2006 - 2009 Cadillac XLR: Service Bulletin: #PI0299: Harsh Shifts After Replacement of 1-2-3-4 / 3-5-R Clutch Housing

#PI0299: Harsh Shifts After Replacement of 1-2-3-4 / 3-5-R Clutch Housing - (Nov 16, 2010)

Subject: Harsh Shifts After
Replacement of 1-2-3-4 /
3-5-R Clutch Housing

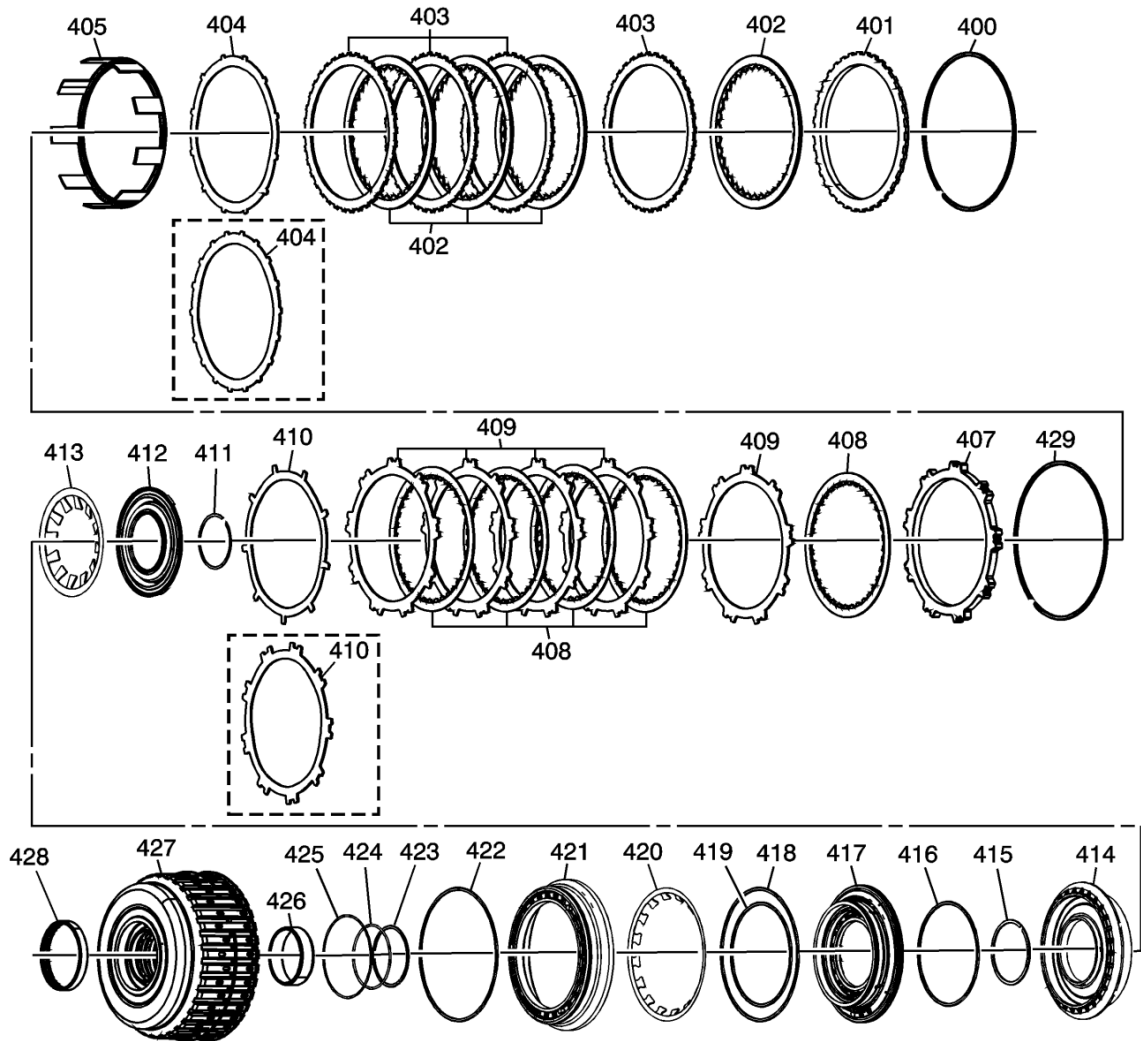
Some customers may comment on harsh shifts after replacement of the 1-2-3-4 / 3-5-R clutch housing (427).

This condition may be caused if the 1-2-3-4 / 3-5-R bearing (428) is not installed into the housing (427). The 1-2-3-4 / 3-5-R clutch housing is currently serviced through parts without this bearing installed and failure to order and install this bearing may result in harsh shifts. Plans are being implemented to service this housing as a kit that will include the bearing.

Note: The parts catalog calls out to order the bearing when the housing is also replaced.
